ELIMINATION OF CREVICE SEAL & O-RING

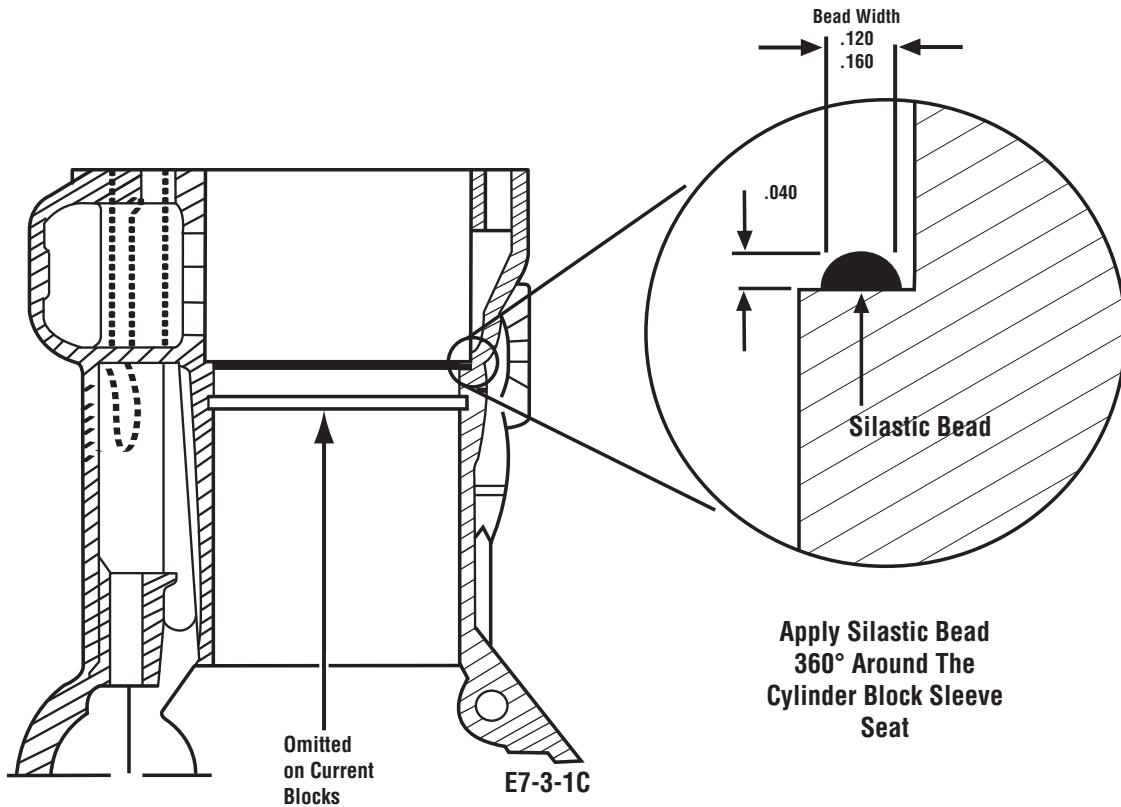
1. Some E-7 Engines have an O-ring groove below the cylinder sleeve seat, and some do not. It has been determined that this O-ring is not required as long as silastic is used at the sleeve shoulder.
2. Clean liner & block to assure removal of all contamination & oil.
3. Apply a .120 to .160 inch bead of RTV Silicone (PAI BSR-0385, Dow Corning #RTV732, or General Electric #RTV103 Silastic Sealant) to the cylinder block sleeve shoulder 360°. **DO NOT** use excessive amount. Sealant must be applied just prior to installation of the sleeves to prevent partial curing and questionable sealing and bonding.

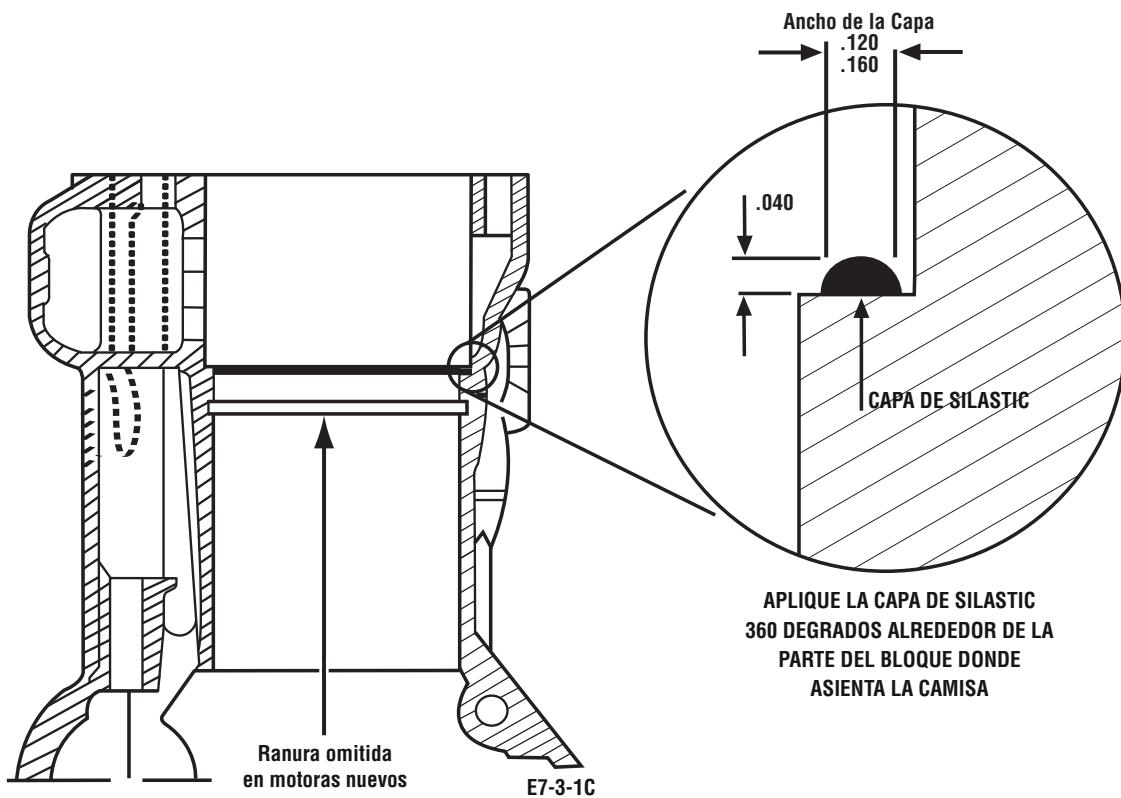
4. From the beginning of E7 PLN and E-Tech™ engine production, a crevice seal, similar to an o-ring, was installed in the groove located in the outside diameter of the cylinder sleeve, near the sleeve top.

It has been determined, however, that the crevice seal is not necessary. Therefore, effective approximately December 1998(engine serial number series 8Y), the crevice seal is no longer used in production engines.

Additionally, effective January 1999 (engine serial numbers series 9A), the crevice seal groove in the cylinder sleeve has been eliminated.

Effective with these production changes, cylinder sleeve part number ESL-8288 for service use will not have the crevice seal groove, and it is recommended that use of the crevice seal be discontinued in all engine repairs or rebuilds, whether or not the liner has a crevice seal groove.
